UNITED STATES PATENT AND TRADEMARK OFFICE

APPLICATION NO.	FILING DATE	FIRST NAMED INVENTOR	ATTORNEY DOCKET NO.	CONFIRMATION NO.
10/693,545	10/23/2003	Jung-Im Kim	3364P140	3620

Office Action Summary	Application No.	Applicant(s)	
	10/693,545	KIM ET AL.	
	Examiner	Art Unit	
	Guy J. Lamarre	2133

FIG. 2

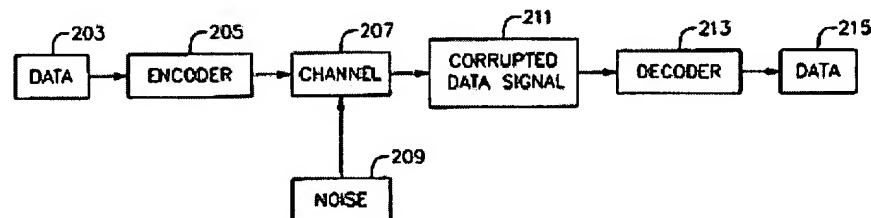
Not specifically described in detail in Admitted prior art is the step whereby turbo coding can be replaced by LDPC (low density parity check) coding.

However, **Shen**, in an analogous art, discloses algorithms wherein such code substitution techniques are described. {See **Shen**, Id., Fig. 2 and col. 3 lines 19-26, 65-67, col. 4 lines 1-14 et seq.}

Therefore, it would have been obvious to a person having ordinary skill in the art at the time the invention was made to modify the procedure of the **Admitted prior art** by including therein code substitution methods as taught by **Shen**, because such modification would provide the procedure disclosed in the **Admitted prior art** with a technique whereby data processing is optimized by ‘as much as 10 dB performance improvement’ via selection of appropriate coding type. {See **Shen**, col. 1 line 30.}
